Docket Item # 12
BAR CASE # 2017-00178

BAR Meeting
June 7, 2017

ISSUE: Certificate of Appropriateness for Alterations
APPLICANT: Casey Keplinger
LOCATION: 907 Green Street
ZONE: RM/Residential

BAR Case #2017-00178
907 Green Street

UNIT SECTIONS
 Aluminum-Clad Exterior

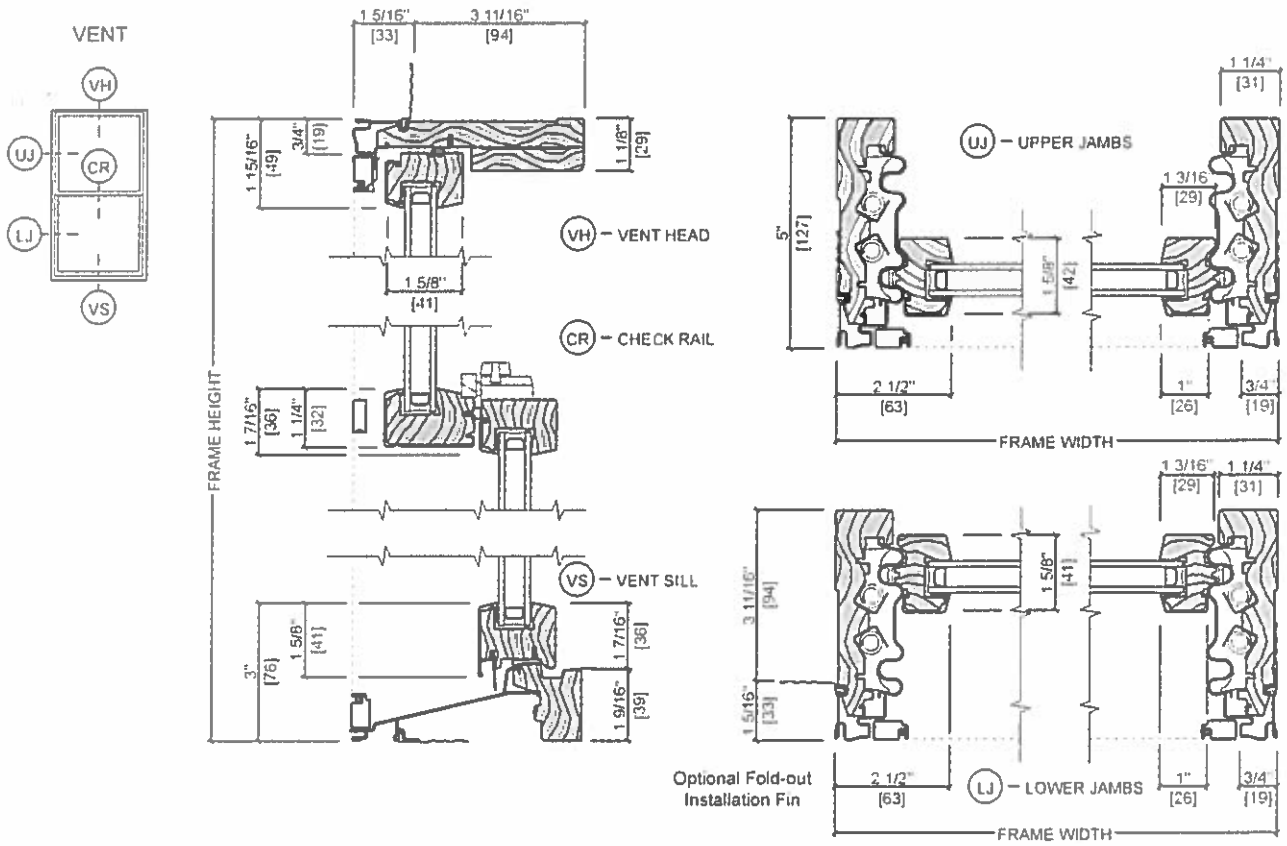
The applicant is seeking a Certificate of Appropriateness to replace all nine, 6/6 true-divided-light (TDL), single-glazed wood windows on the north and south elevations of the attached rowhouse with simulated-divided-light (SDL), white colored, aluminum-clad wood windows in a matching muntin configuration. The glass is insulated Low-E 272 with a light bronze-colored shadow bar. The exterior (simulated) grilles (or muntins) will be 7/8 inch wide with a putty profile. The existing storm windows will be removed and will not be replaced.

Staff supports removal of the storm windows, which by policy are not reviewed by the BAR. Although storm windows provide energy savings and protect historic sash, these are not considered historic and the proposed new sash will be aluminum clad.

The BAR's general policy is to support materials *which would have been commercially available at the time of construction of that portion of the building*. Aluminum cladding over wood is a modern invention that became commercially available around 1965. In general, the BAR's concern has been for historically appropriate materials because the overwhelming majority of the structures in the historic districts in Old Town are built to the front lot line, allowing pedestrians to have a close view of the material from the public sidewalk. The OHAD BAR has occasionally approved clad windows on mid-20th century houses that were set back from the sidewalk on a case-by-case basis. In this case, the house has a front yard and is set back behind a low retaining wall approximately 20'. Staff supports removal of the existing windows, frames and trim because the house was constructed ca 1940 and its windows never had the hand crafted characteristics of historic windows made with cylinder glass or mortice and tenon sash valued by the BAR, as these were no longer produced by 1930.

In this location in the district, on this age dwelling and set back this distance from the sidewalk, BAR staff supports the use of aluminum-clad wood windows.
